LLFA CORRESPONDENCE

DRAINAGE CONSULTATION ON PREAPP/00091/22

Consultation Response on behalf of Head of Highways and Engineering

Land at Stakehill, Middleton. Hybrid planning permission is sought for up to 1500 dwellings, a new local centre, land reserved for the extension of St John's Primary School, a landscaping scheme & sustainable drainage measures.

Dwg No.: A3/ThornhamLa/01

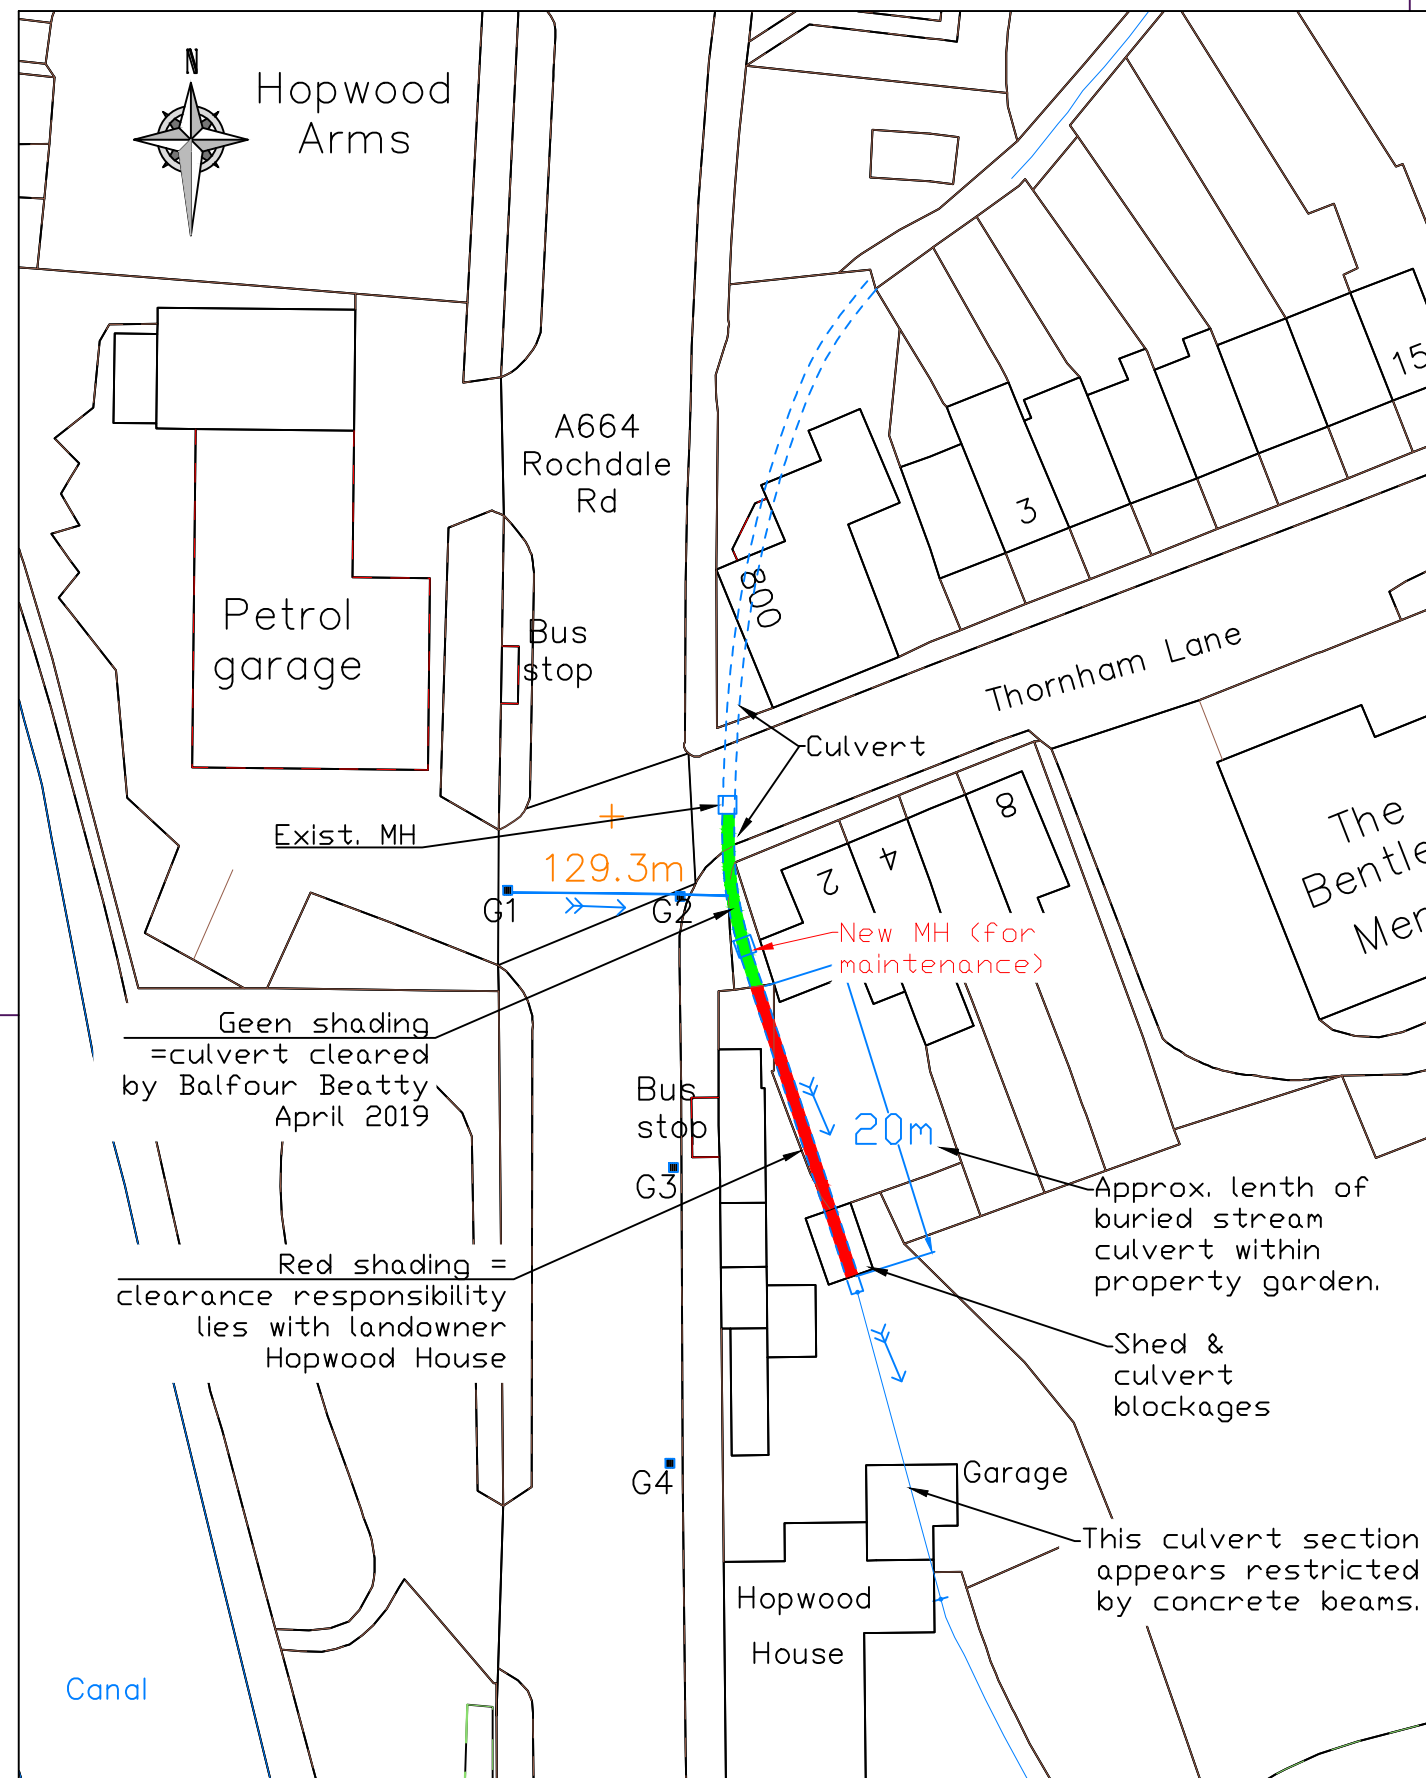
Photo 1: of silt looking towards Hopwood House. 70cm deep silt & 30cm freeboard (clear)

Photo 2:- Deep layer of silt still in culvert under Hopwood House 'garden' (April 2019).

Photo 3: Steel drooping into culvert under shed (Hopwood House)

Photo 5: Beam partially blocking culvert under garage (Hopwood House)

Project: STAKEHILL AREA
OS MAP BACKGROUND
Title: DRAINAGE NOTES
on Redrow phase 1

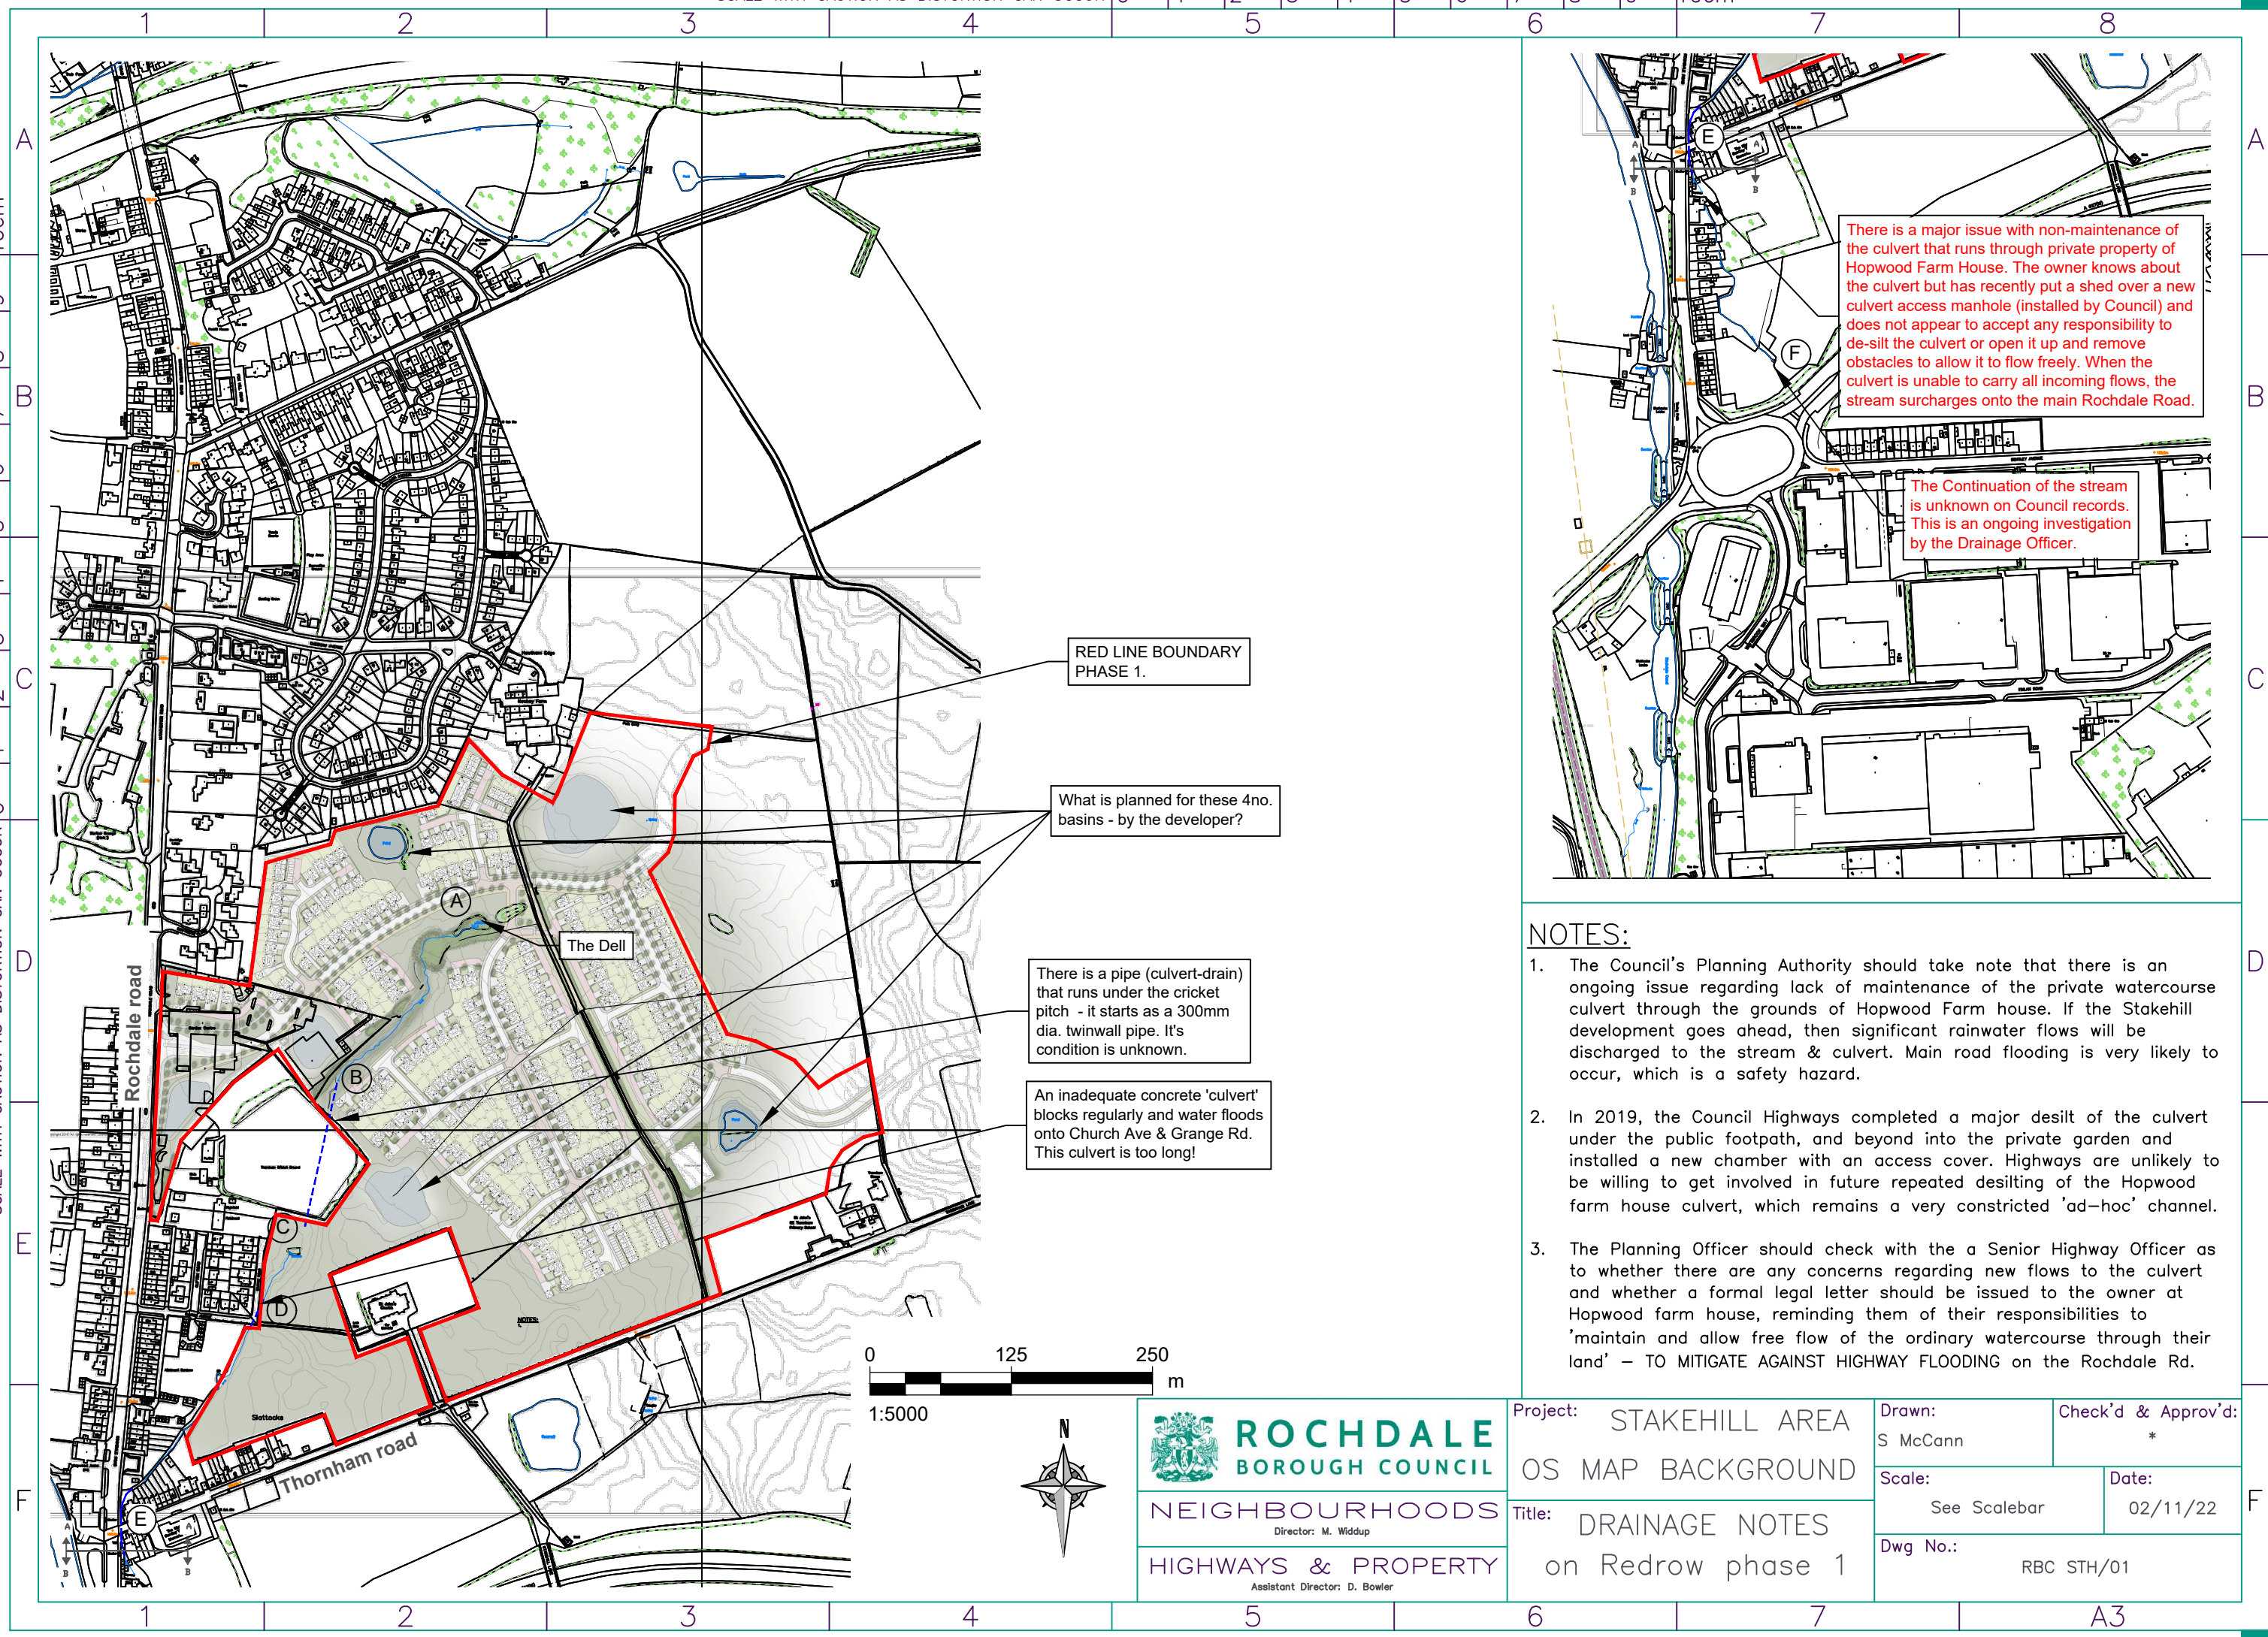
There is a major issue with non-maintenance of the culvert that runs through private property of Hopwood Farm House. The owner knows about the culvert but has recently put a shed over a new culvert access manhole (installed by Council) and does not appear to accept any responsibility to de-silt the culvert or open it up and remove obstacles to allow it to flow freely. When the culvert is unable to carry all incoming flows, the stream surcharges onto the main Rochdale Road.

The Continuation of the stream is unknown on Council records. This is an ongoing investigation by the Drainage Officer.

1. The Council's Planning Authority should take note that there is an ongoing issue regarding lack of maintenance of the private watercourse culvert through the grounds of Hopwood Farm house. If the Stakehill development goes ahead, then significant rainwater flows will be discharged to the stream & culvert. Main road flooding is very likely to occur, which is a safety hazard.

2. In 2019, the Council Highways completed a major desilt of the culvert under the public footpath, and beyond into the private garden and installed a new chamber with an access cover. Highways are unlikely to be willing to get involved in future repeated desilting of the Hopwood farm house culvert, which remains a very constricted 'ad-hoc' channel.

3. The Planning Officer should check with the a Senior Highway Officer as to whether there are any concerns regarding new flows to the culvert and whether a formal legal letter should be issued to the owner at Hopwood farm house, reminding them of their responsibilities to 'maintain and allow free flow of the ordinary watercourse through their land' – TO MITIGATE AGAINST HIGHWAY FLOODING on the Rochdale Rd.
